AMENDED
01 NOV 2013
BY ZOE ECA
(name)
MEDQ

CLIENT
ECONOMIC DEVELOPMENT
QUEENSLAND
PROJECT
HILLCLOSE
HARVEY ROAD
CLINTON

PLAN OF DEVELOPMENT
STAGE 4, 4B,
7A & 7B
ALLOTMENT LAYOUT

PLANS AND DOCUMENTS
referred to in the PDA APPROVAL
05 NOV 2013
MEDQ

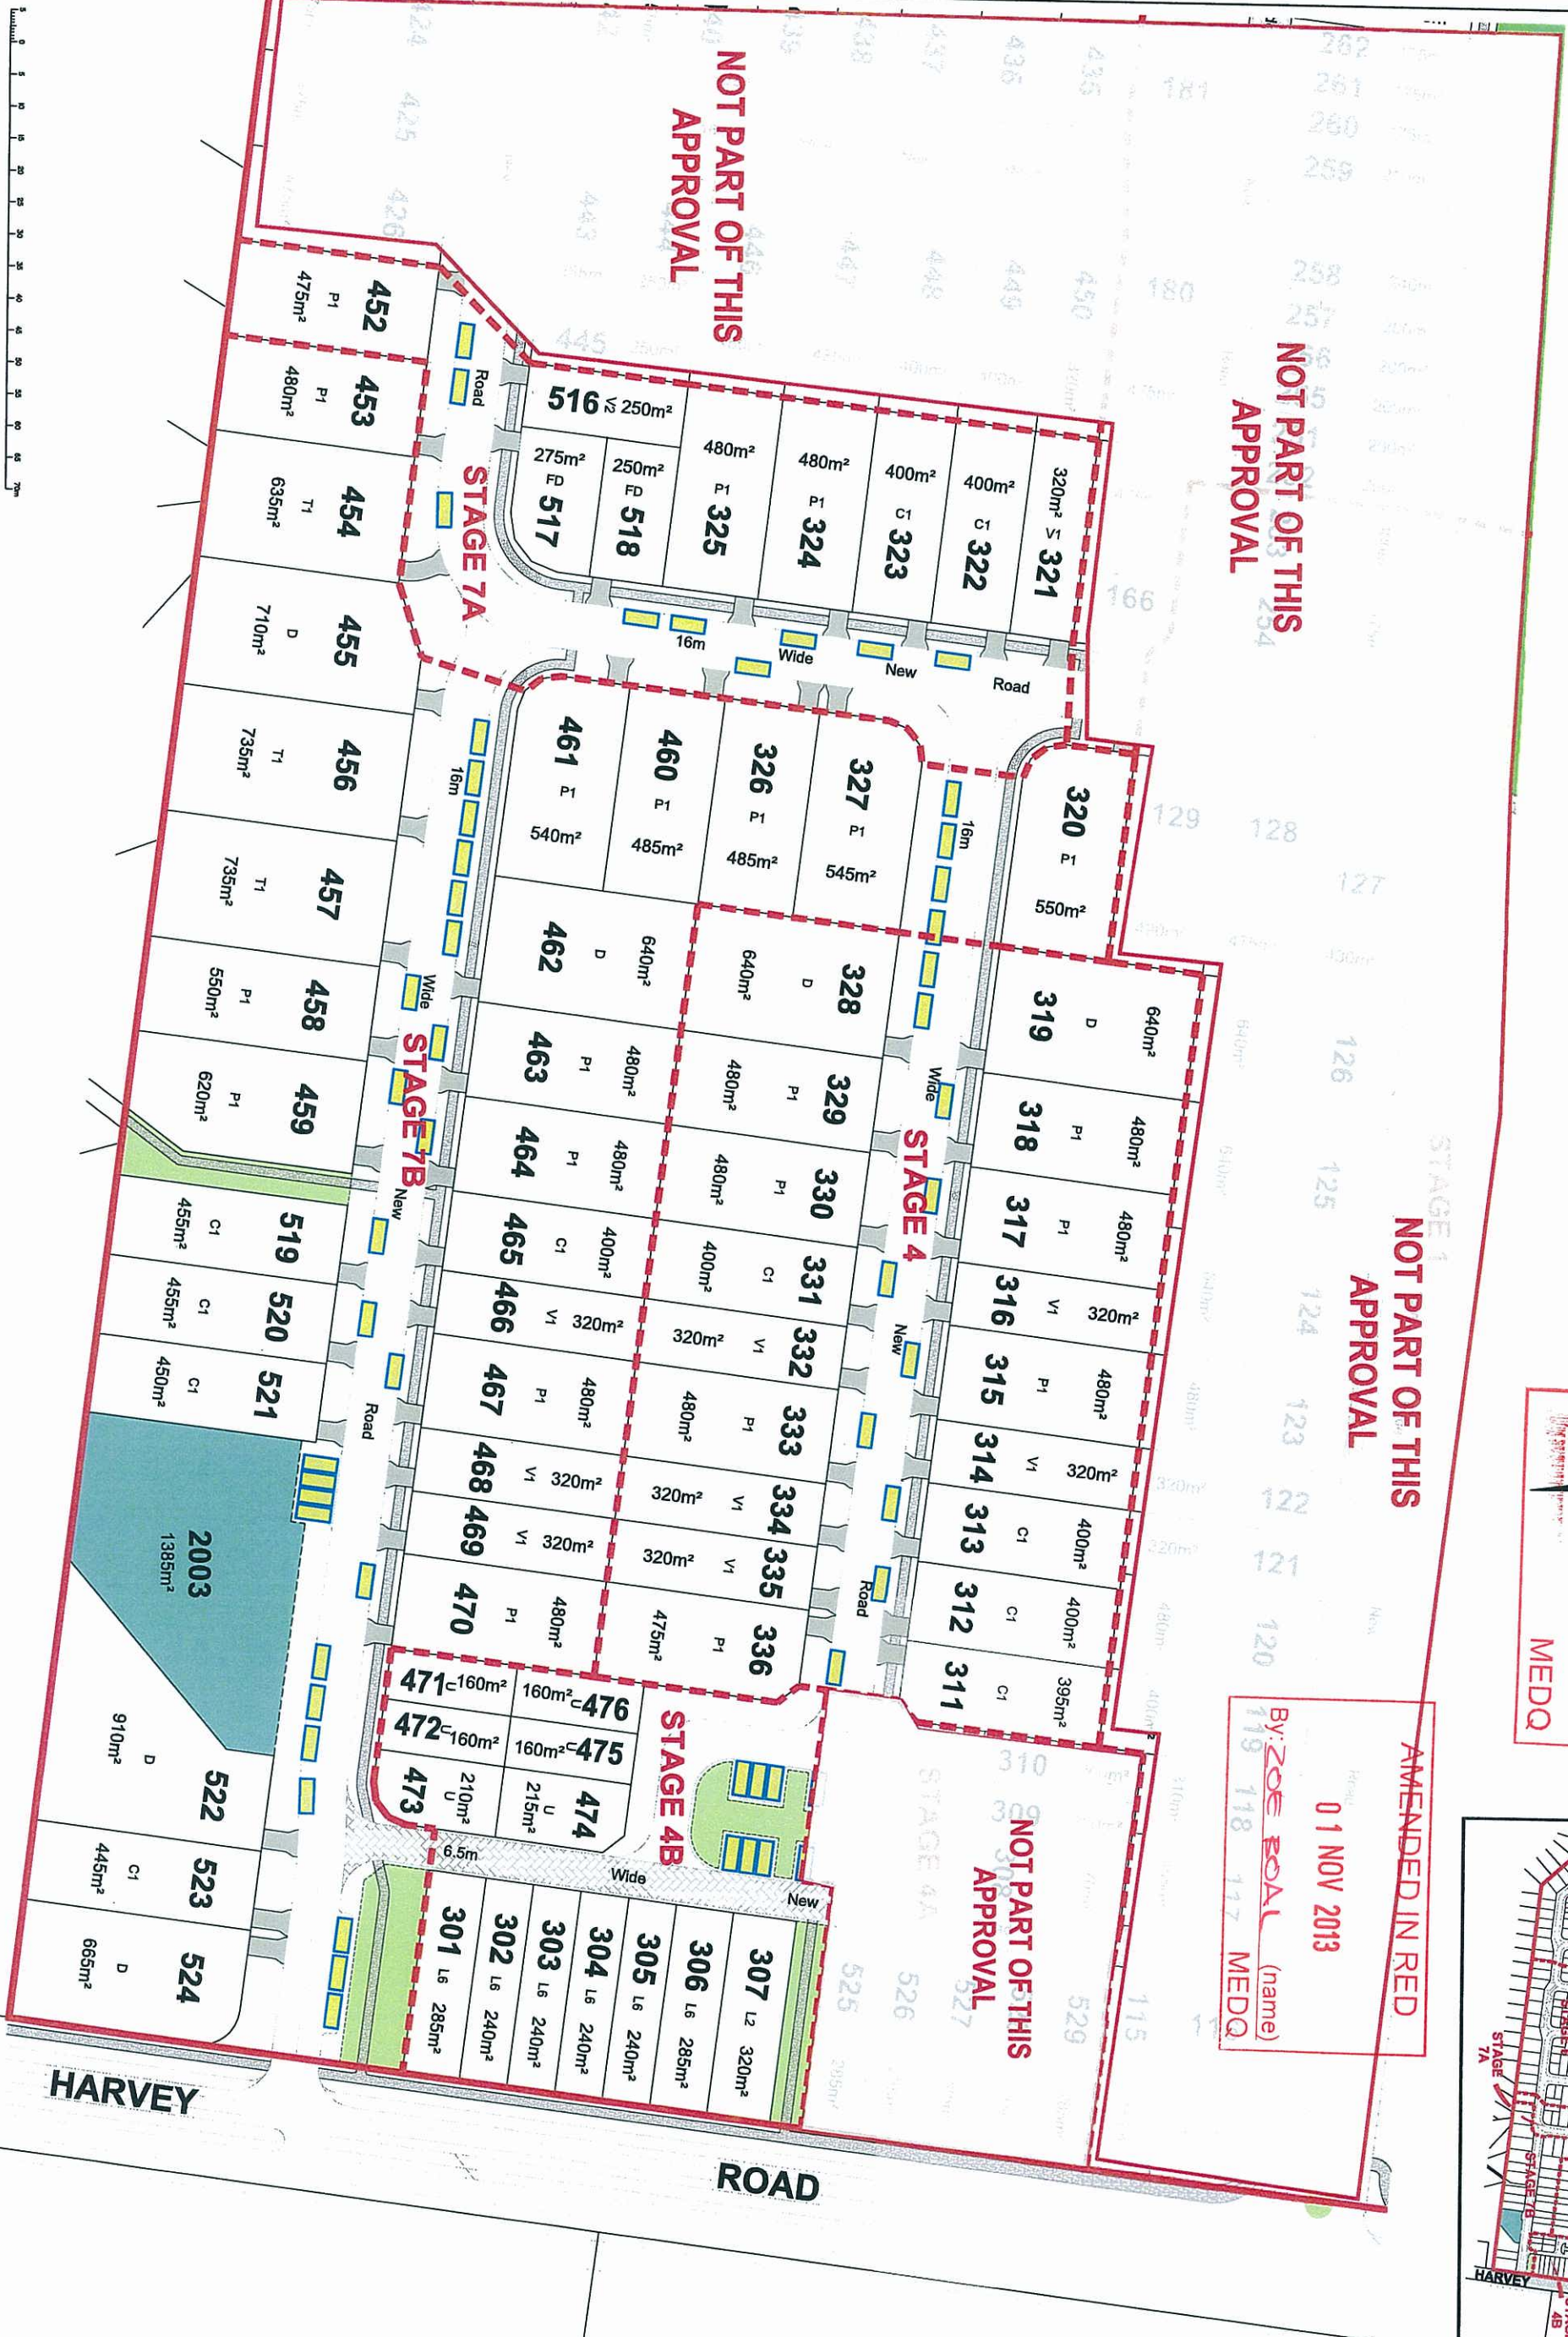
NOT PART OF THIS
APPROVAL

NOT PART OF THIS
APPROVAL

AMENDED IN RED
01 NOV 2013
By: ZOE BOAL (name)
119 118 117 MEDQ

NOT PART OF THIS
APPROVAL

NOT PART OF THIS
APPROVAL

~~STAGE 5~~ - HILL CLOSE DA CONCEPTS - LOTS ~~369 & 370~~
406-407 and 441-442

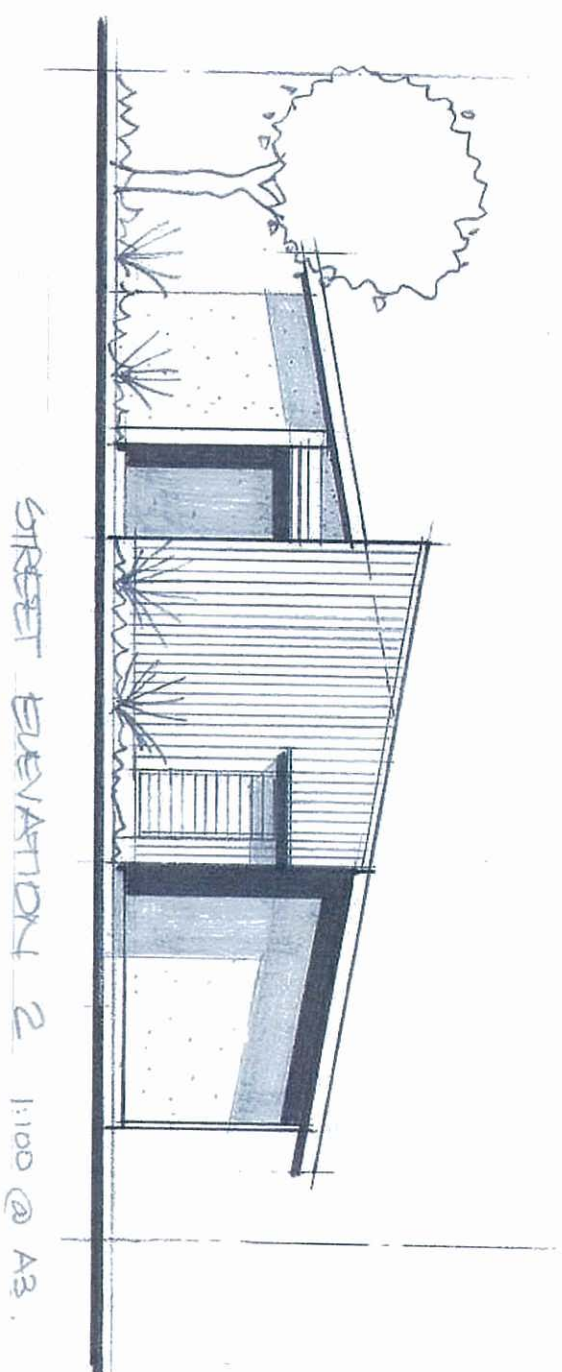
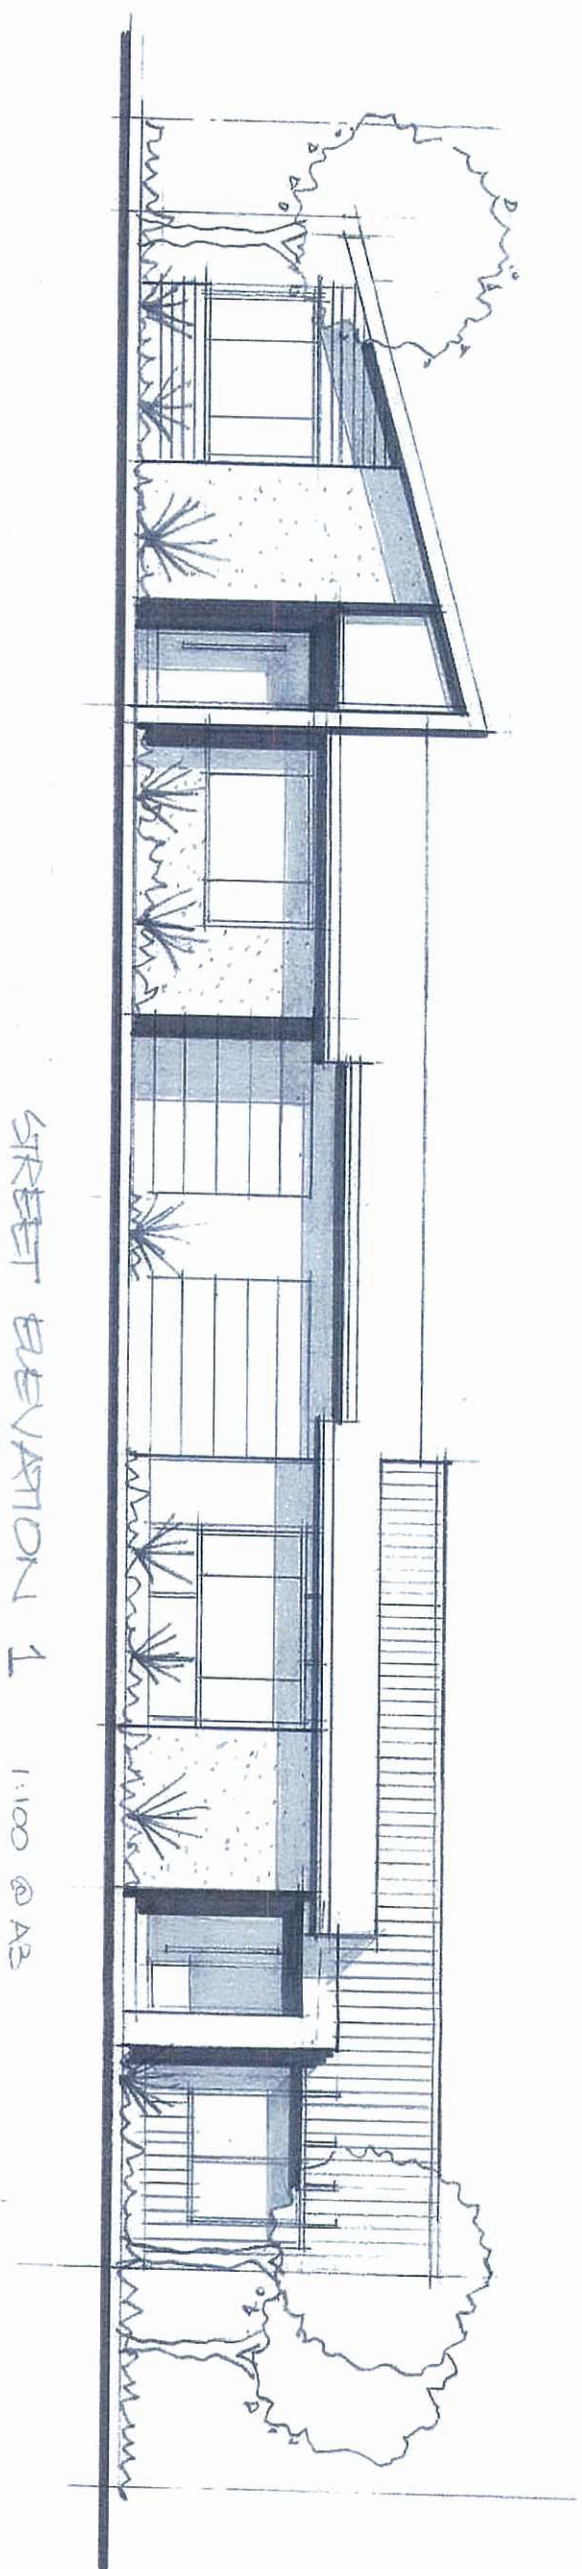
A MENDED IN RED
18 SEP 2012
By: BRIANNA PYFEE (name)
of the ULDA

LOT 406-407 and 441-442
LOT 369-370

HILL CLOSE ~~386-387~~

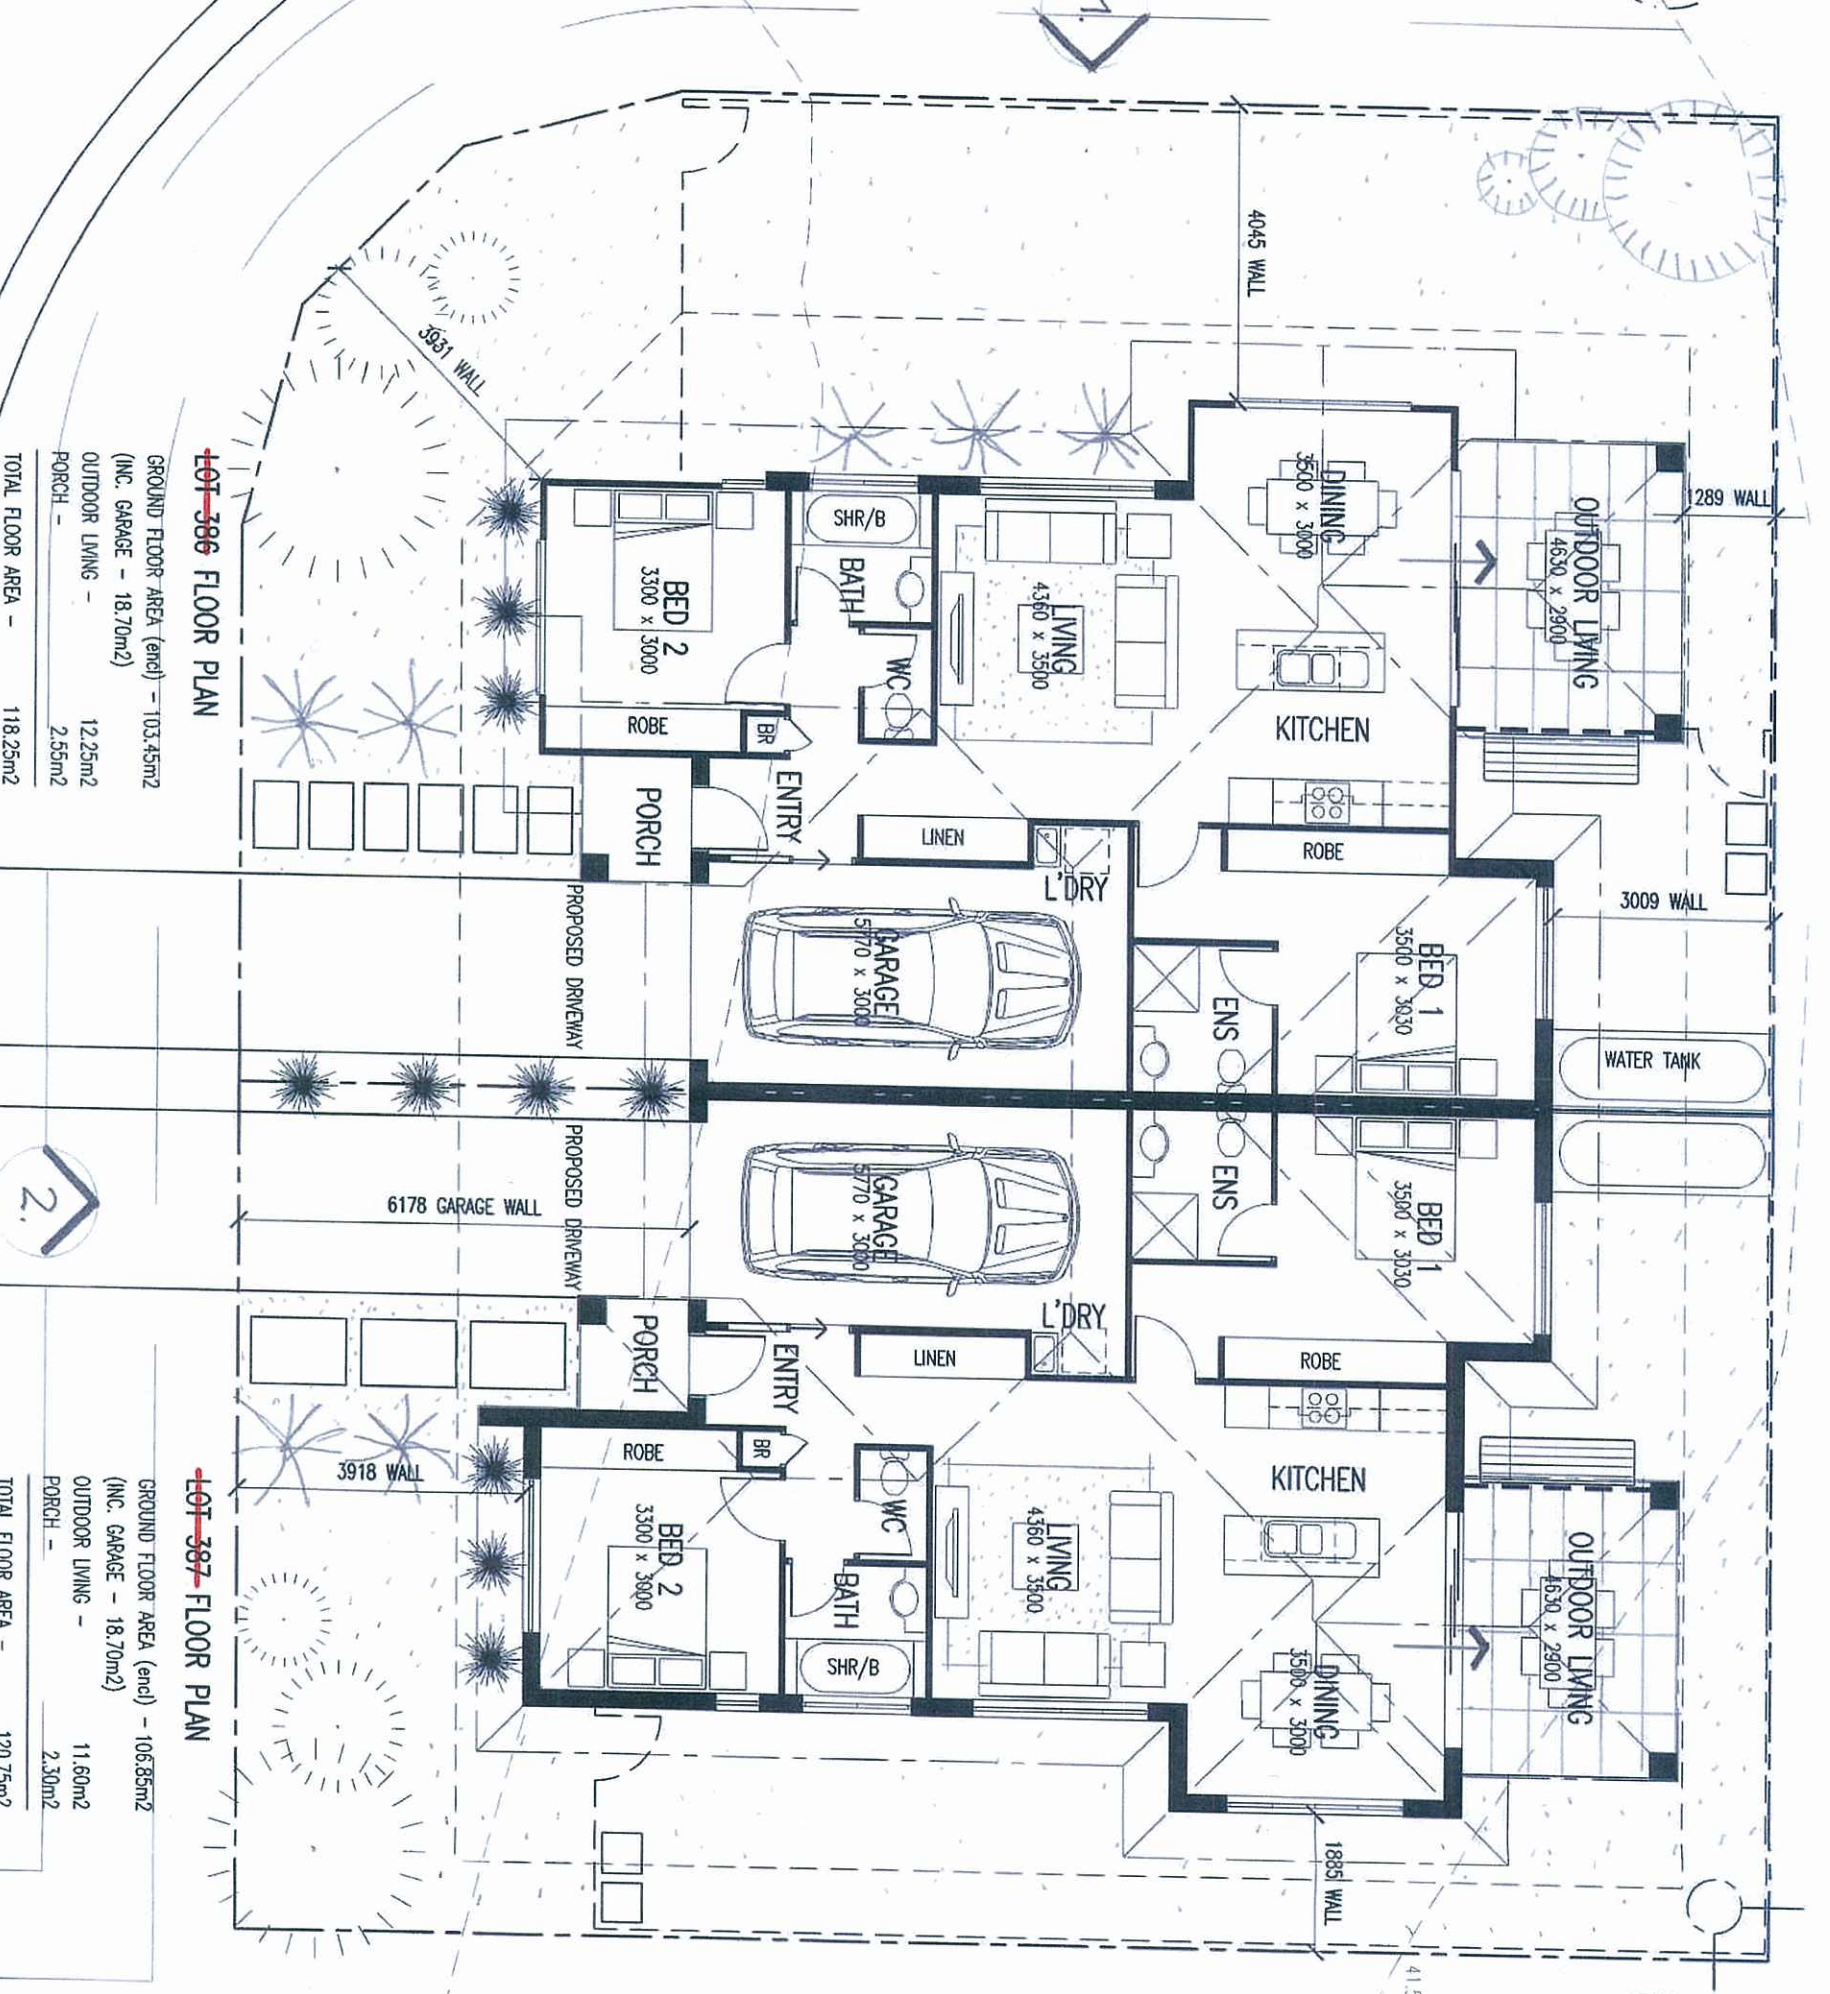
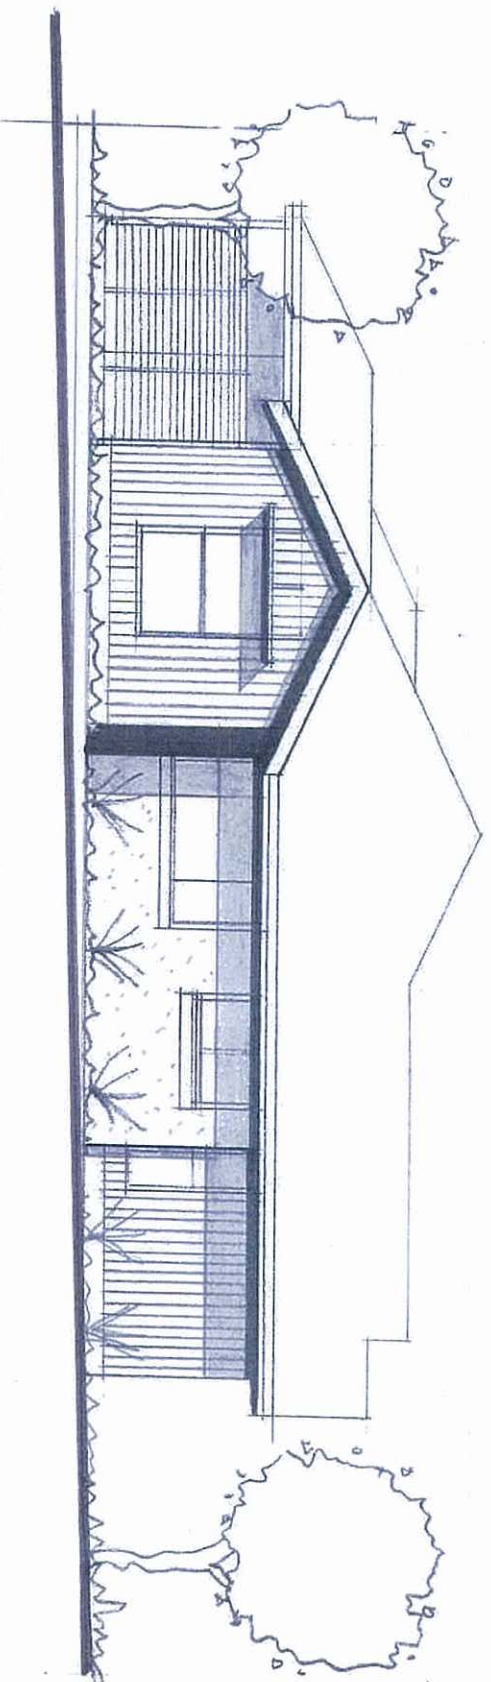
A MENDED IN RED
18 SEP 2012

~~LOT 386-387~~

~~388-389, 404-405, 427-428 and 443-444~~

Site: LOT ~~386-387~~ HILL CLOSE ESTATE
